ADDENDUM NUMBER 1
TO THE DRAWINGS AND SPECIFICATIONS

PROJECT: McLean County Unit District No. 5 Parking Lot and Driveway Repairs at 2 Locations

A/E PROJECT NO: 24732319 (Normal Community West High School)
24902319 (Pepper Ridge Elementary School)

ATTACHMENT: Sheet C-2: Curb Detail Addendum No. 1

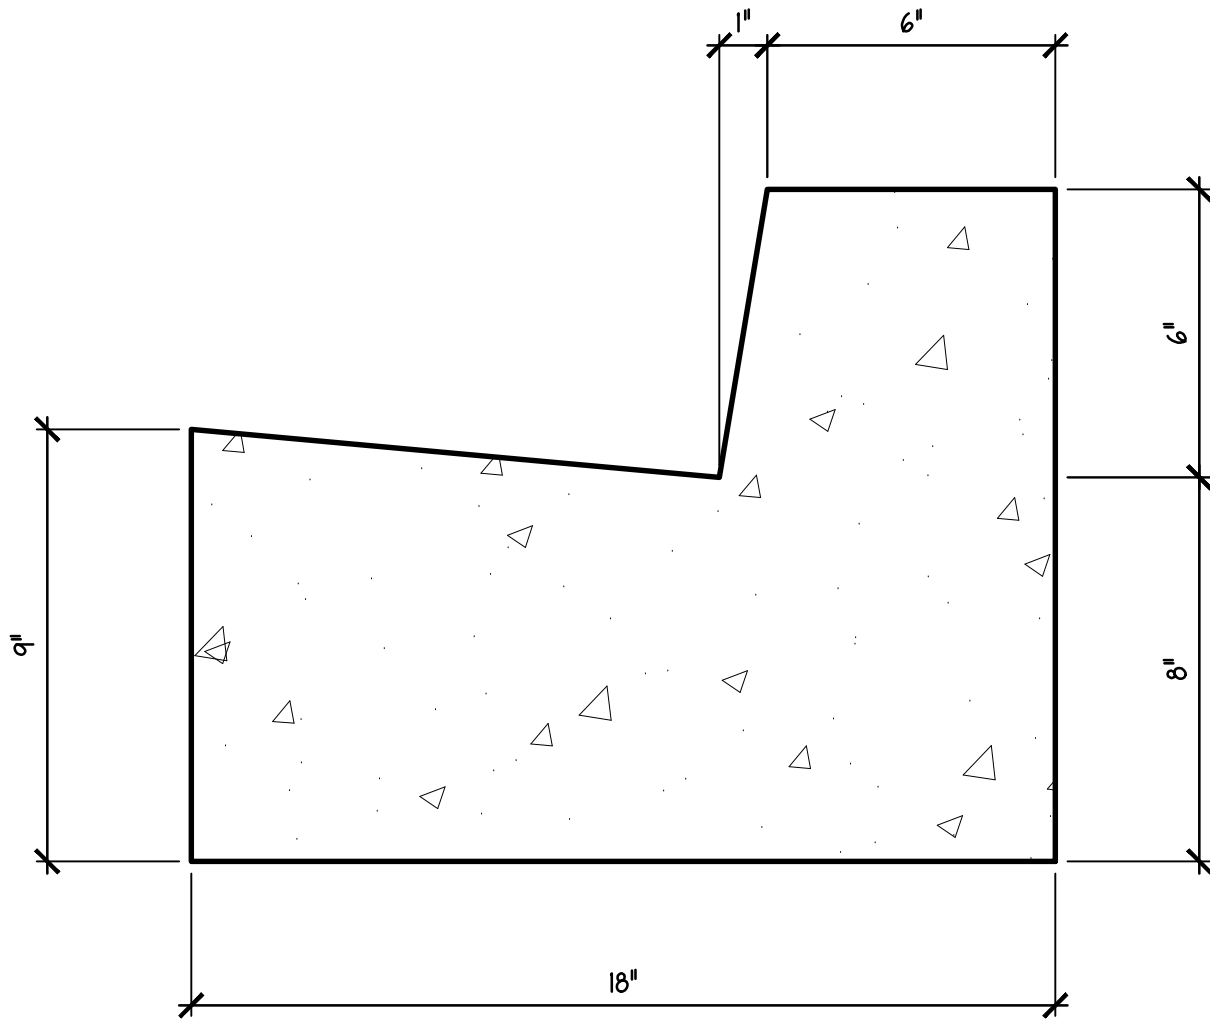
2. TO THE DRAWINGS: Pepper Ridge Elementary School, Job # 24902319: Sheet C-1.0 will have curb and gutter added and the rip rap may be deleted except for two cubic yards at the point of drainage at the northeast corner. At the north 22', install a laydown at 20' to the corner; then south 28' then eliminate the curve going straight 28' at about 30°; then straight south 25'; then form at 45° corner and install 10' of curb and gutter; then 38' to the existing sidewalk. The drawing actually shows a double line which was intended to be curb and gutter – the curves can be made straight.

4. TO THE DRAWINGS: Pepper Ridge Elementary School, Job # 24902319: Sheet C-1: The dark double line at the south edge indicates a curb and gutter same dimension as item 2 above. Install a 3' laydown curb 24' from south edge of sidewalk. Install 2 ½ cubic yards of rip rap at the laydown.
